TITLE:	PLAN		
ITEM NO.:	PLYWOOD SHELVING UNIT AT LIBRARY 3700		
DESC.:	By:	Scale:	Job No.
	PD	As Noted	
Status: APPROVED AS NOTED	Date: 2019-01-08	Dwg. No.	07-01

TITLE: Library Shelving Unit And Tables			
ITEM NO:	7		
DESC:	SECTIONS		
DESC:	PLYWOOD SHELVING UNIT AT LIBRARY 3700		
By:	PD	Scale: As Noted	Job No.
Status: APPROVED AS NOTED	Date: 2019-01-08	Dwg. No.	07-03

TITLE: Library Shelving Unit And Tables
ITEM NO: 7
DESC.: SECTIONS
PLYWOOD SHELVING UNIT AT LIBRARY 3700
By: PD Scale: As Noted Job No. Dwg. No.
Status: APPROVED AS NOTED Date: 2019-01-08 **07-04**

PLAN SECTION
SCALE: 1" = 1'-0"
Arch't Ref.: 1E/A-846.00

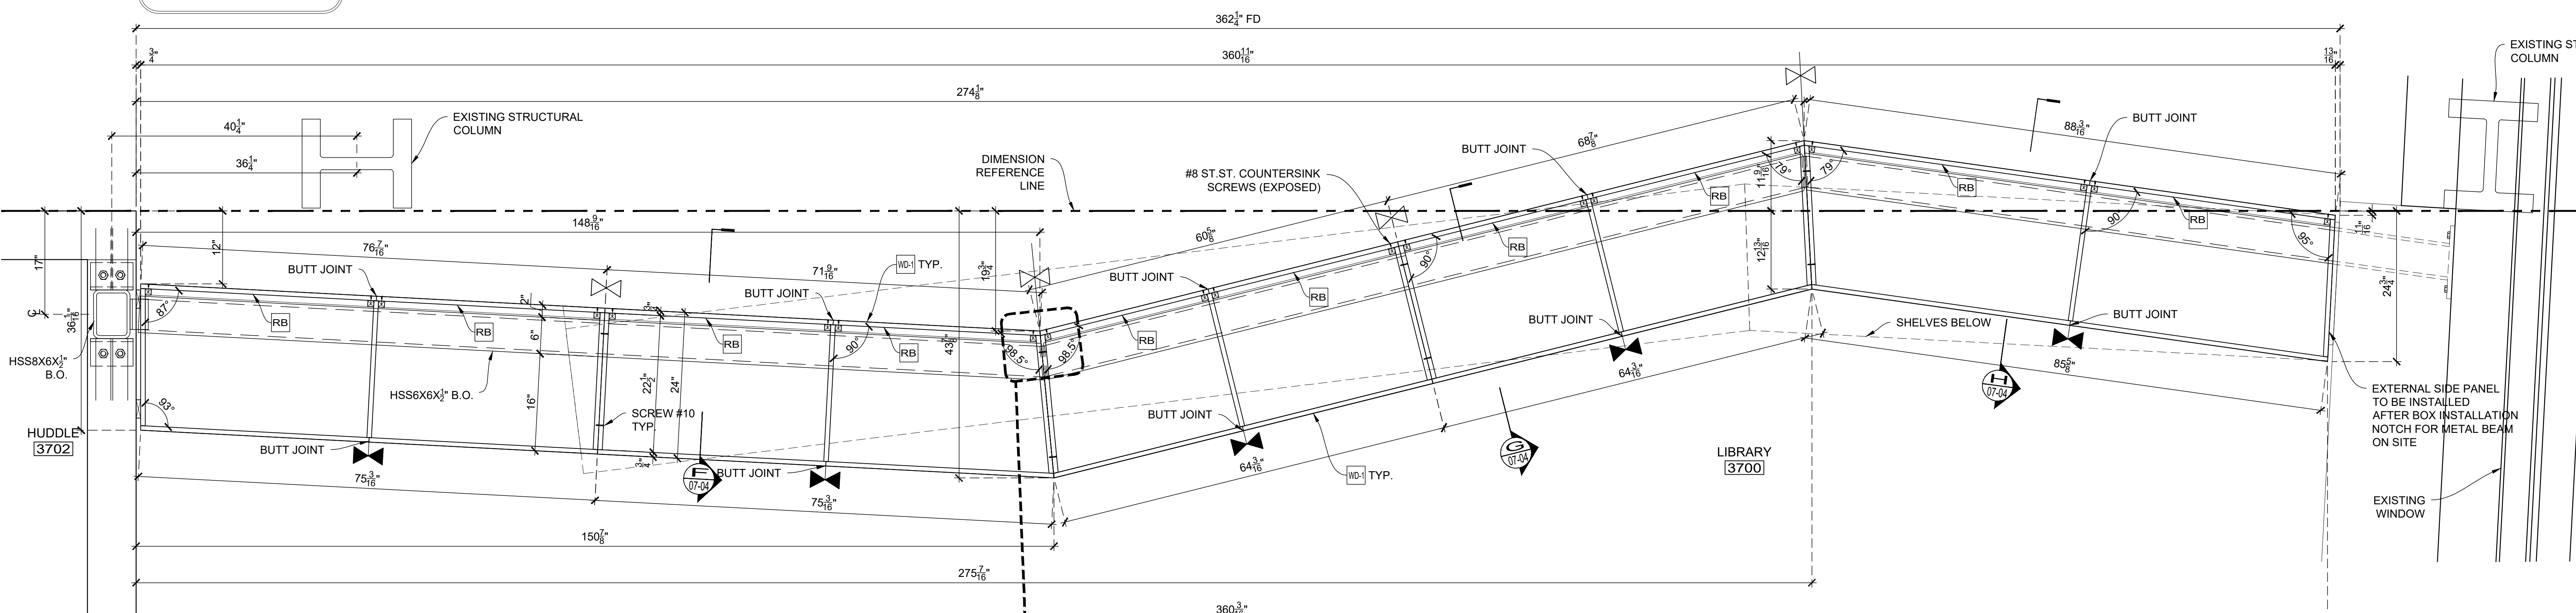
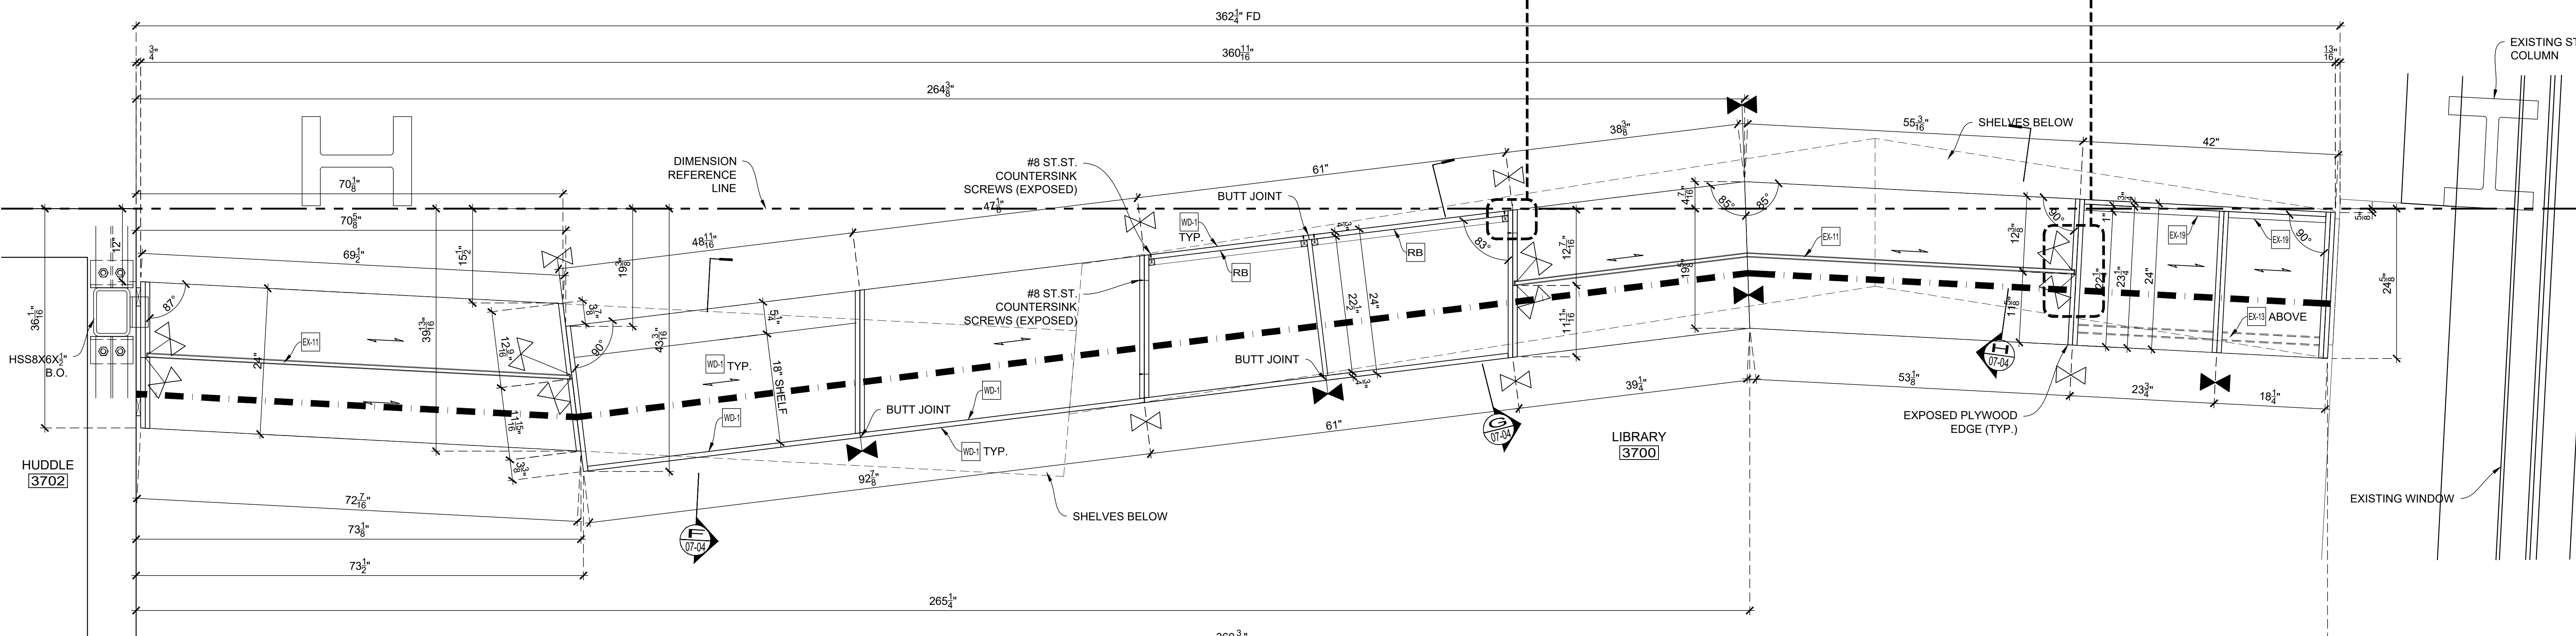
TO BE COORDINATED WITH
STRUCTURAL STEEL DRAWINGS

C PLAN SECTION
SCALE: 1" = 1'-0"
Arch Ref.: 1D/A-846.00

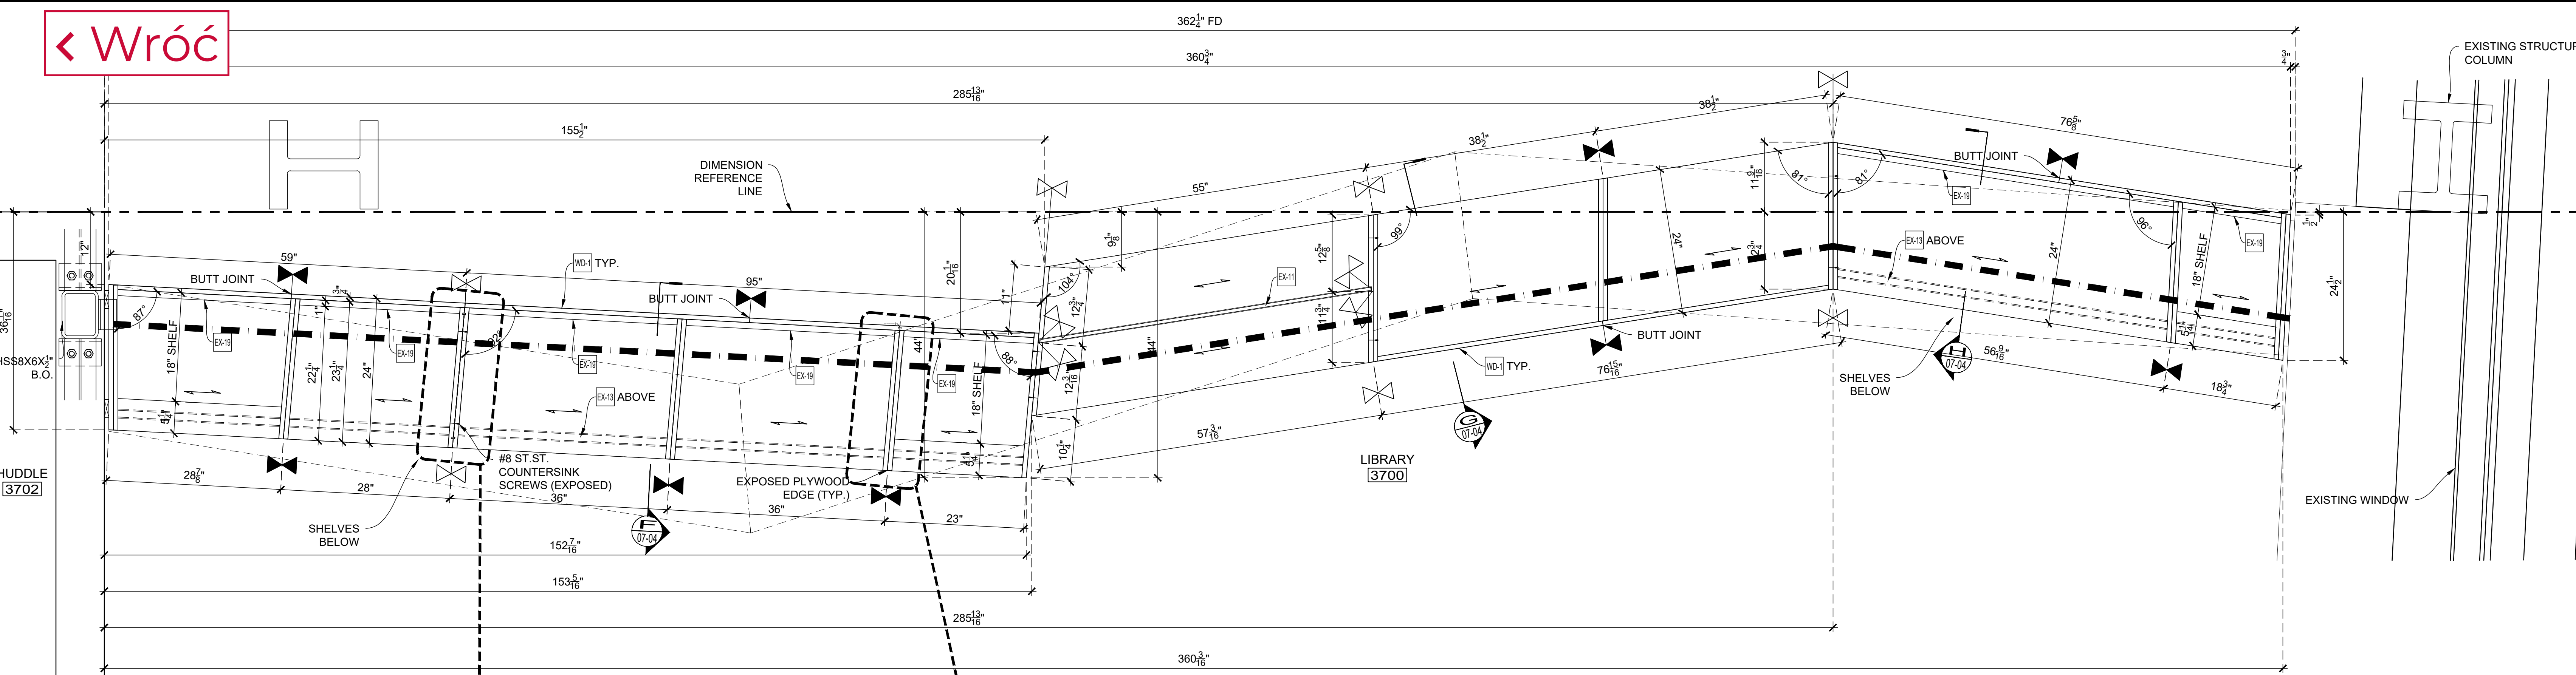
ARCHITECT NOTE:
PLEASE VERIFY ALL LOCATIONS OF LIGHT FIXTURE (EX-13)

PLAN SECTION
SCALE: 1" = 1'-0"
Arch't Ref.: 1/A-845.00, 1/A-846.00

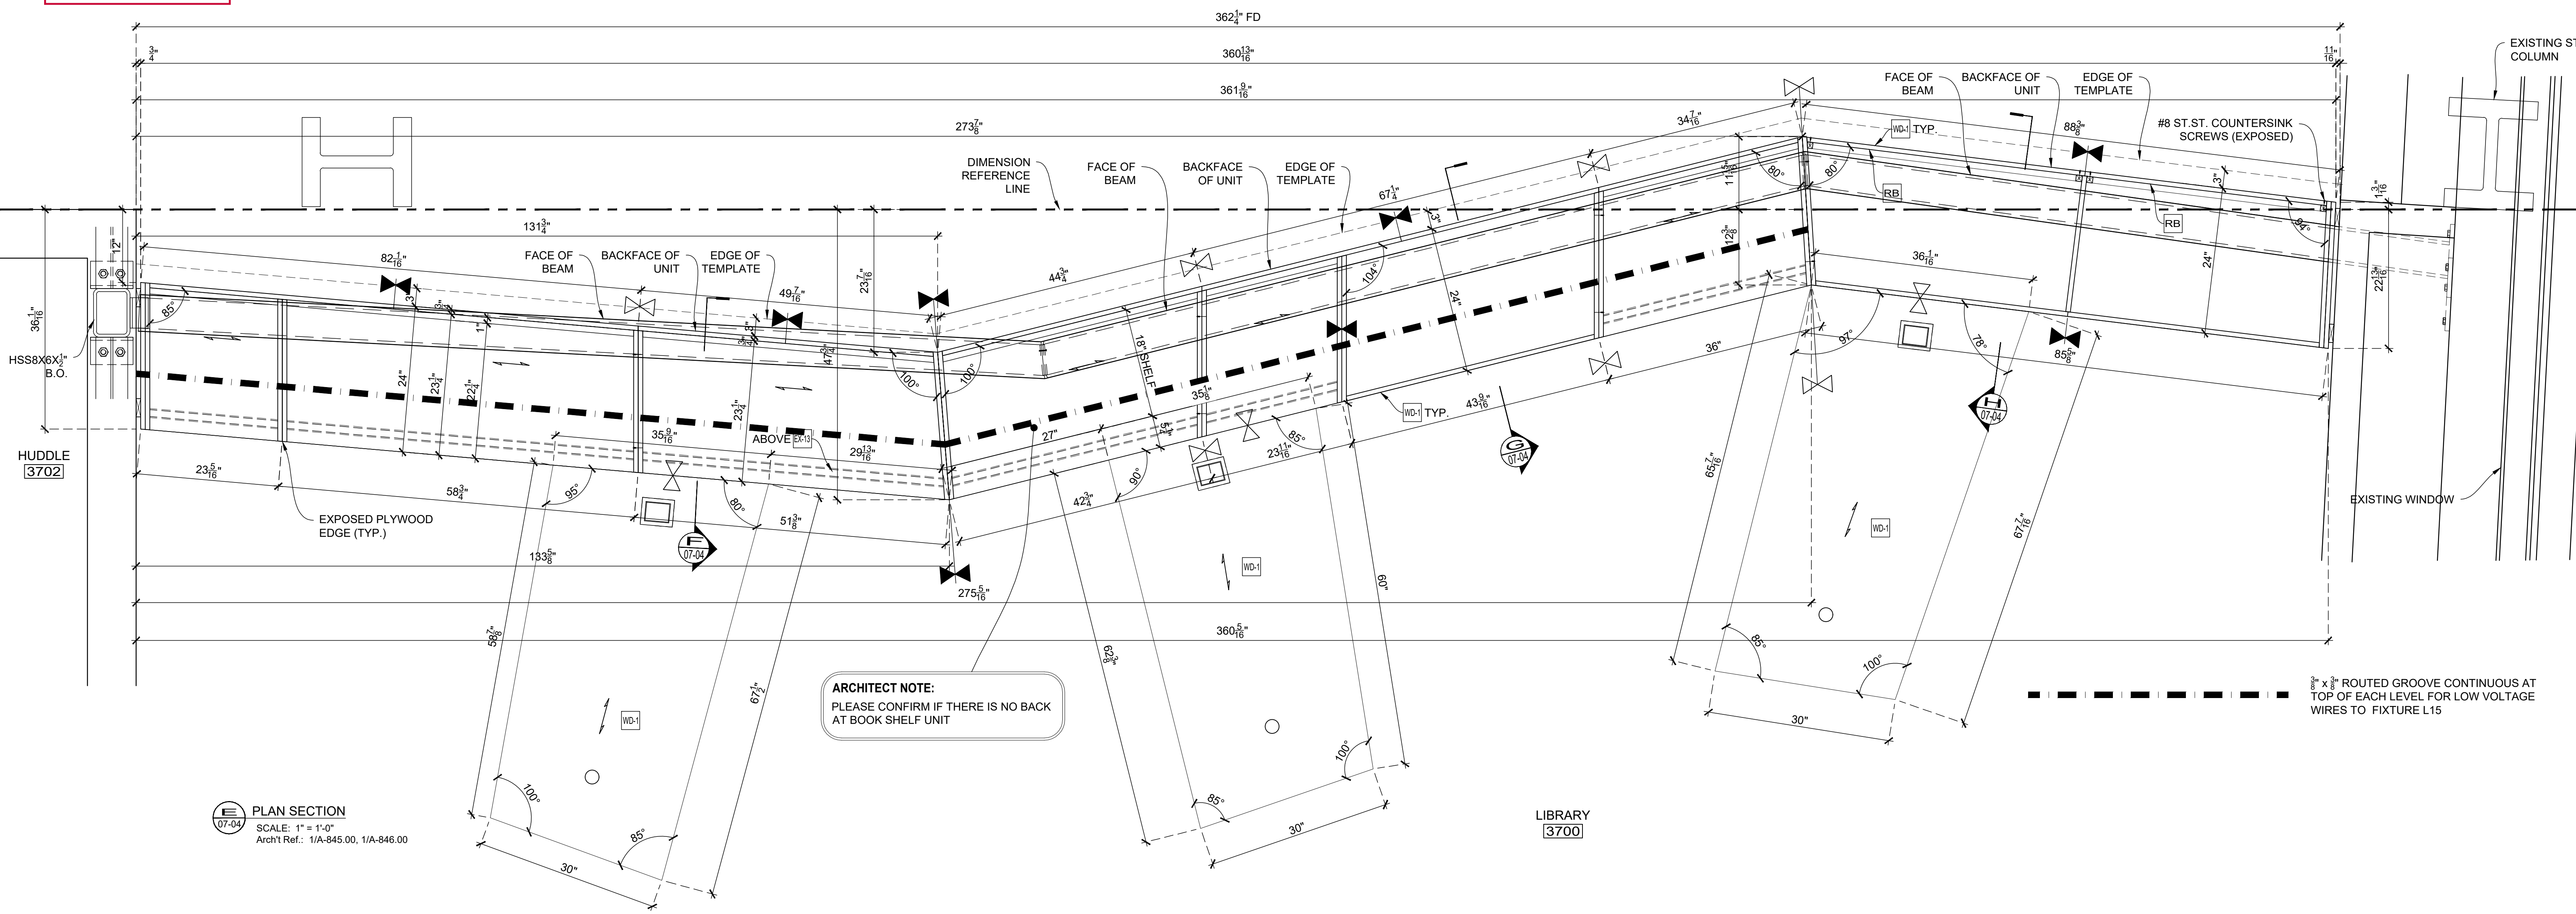
ARCHITECT NOTE:
PLEASE CONFIRM IF THERE IS NO BACK AT BOOK SHELF UNIT

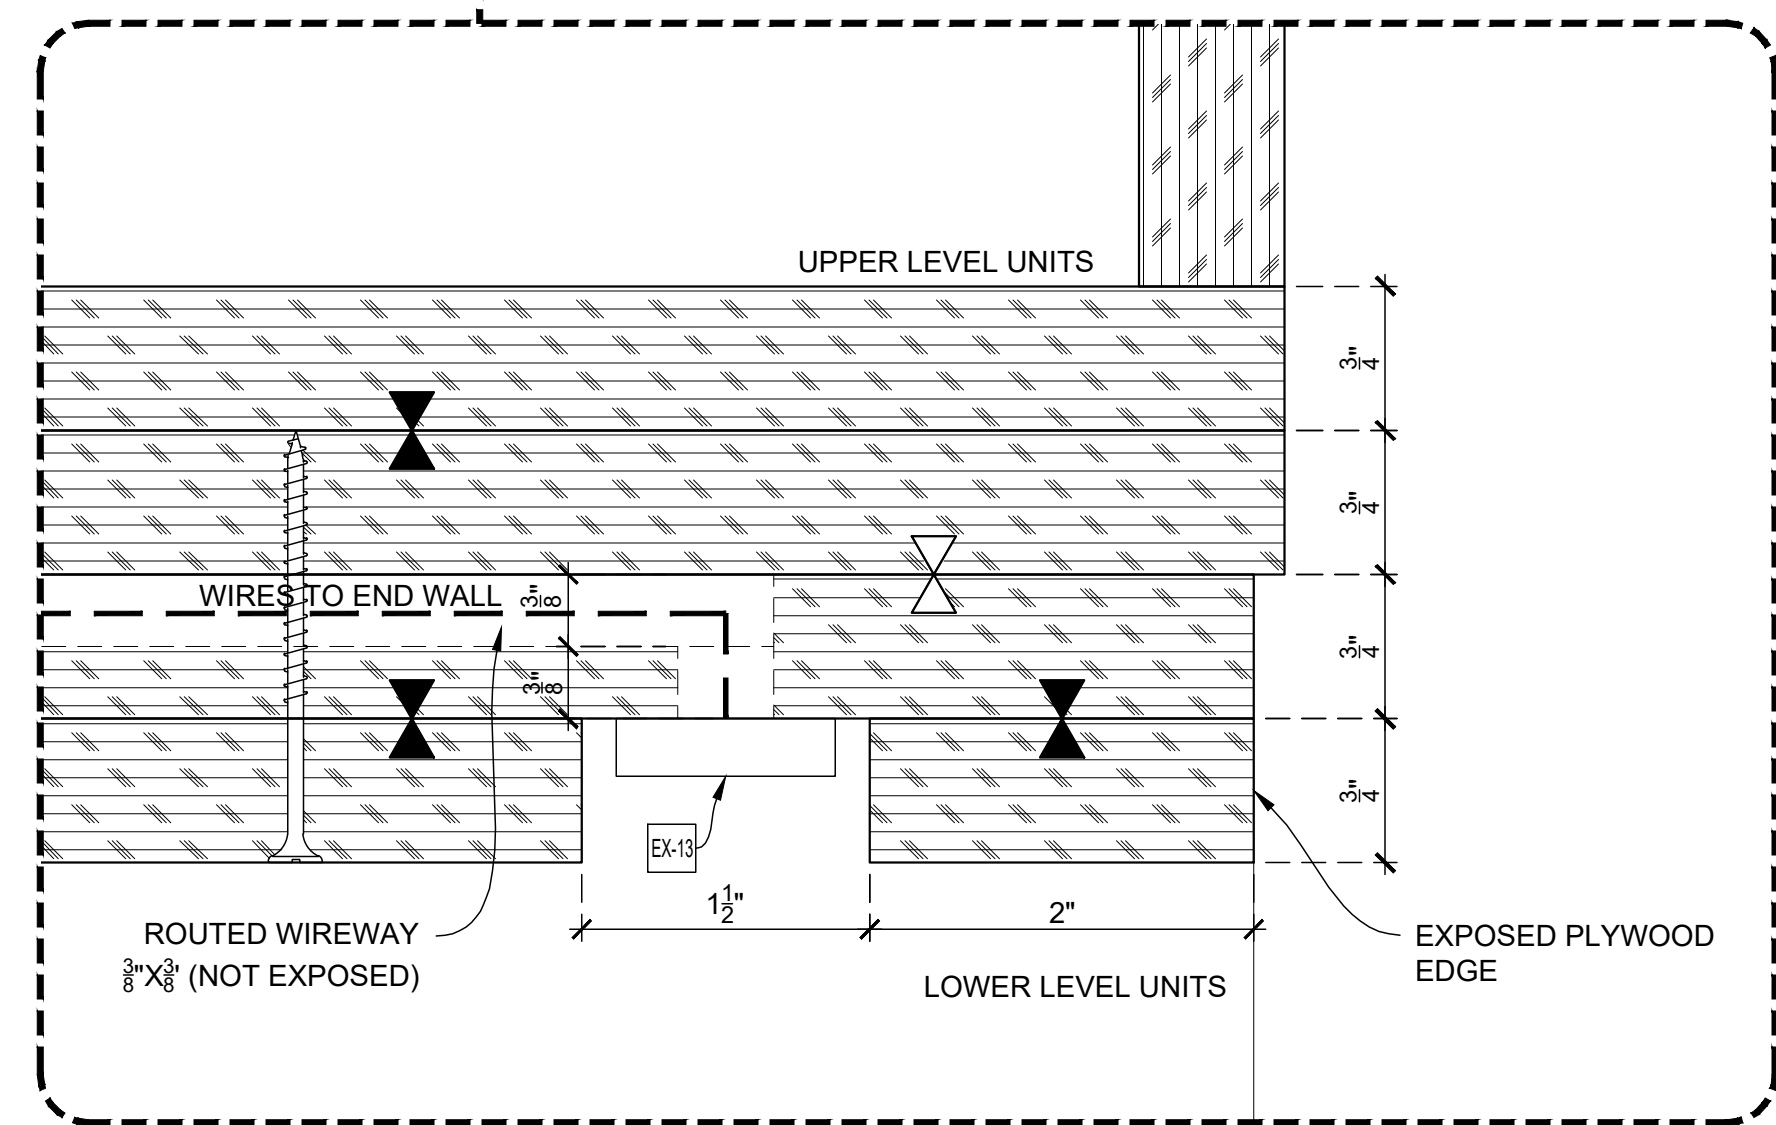
HOLD DIMENSION IF POSSIBLE
